## **Iris Alternative B Criteria**

Community Cycles criteria for Option B (two-way cycle path on North side with 4:3 conversion).

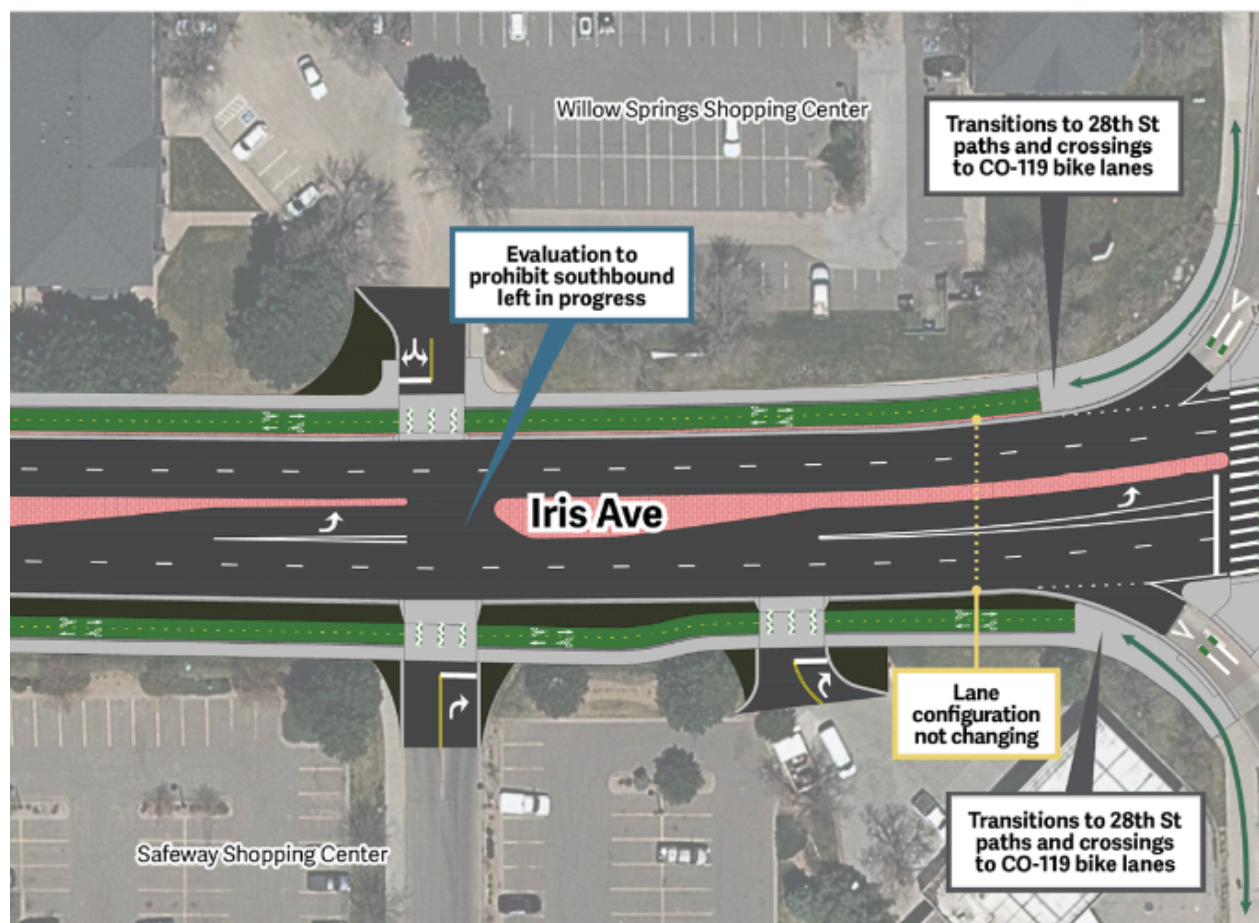
- Design around sufficient bike queuing space (more than 1 bike) for getting people on bikes into the contraflow bike lane portion of 2-way track.
- Design around sufficient bike queuing space (more than 1 bike) for 2 stage turns
- Design to get drivers to queue behind the cycle track AND the sidewalk so that drivers don't stop in either.

**TWO-WAY PROTECTED BIKE LANES  
AND CONNECTION TO ELMER'S TWO MILE**

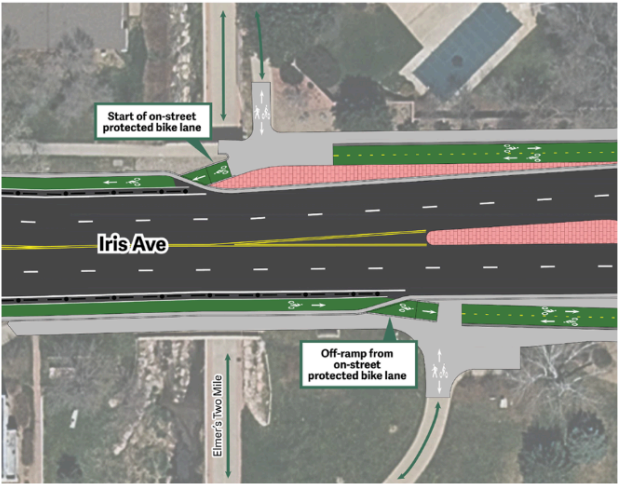
- Add eastbound protected bike lane on the south side of Iris, east of Folsom for bikers heading north on Folsom and then east on Iris. e.g. South side of right panel (below) should look like the bottom of the left panel.
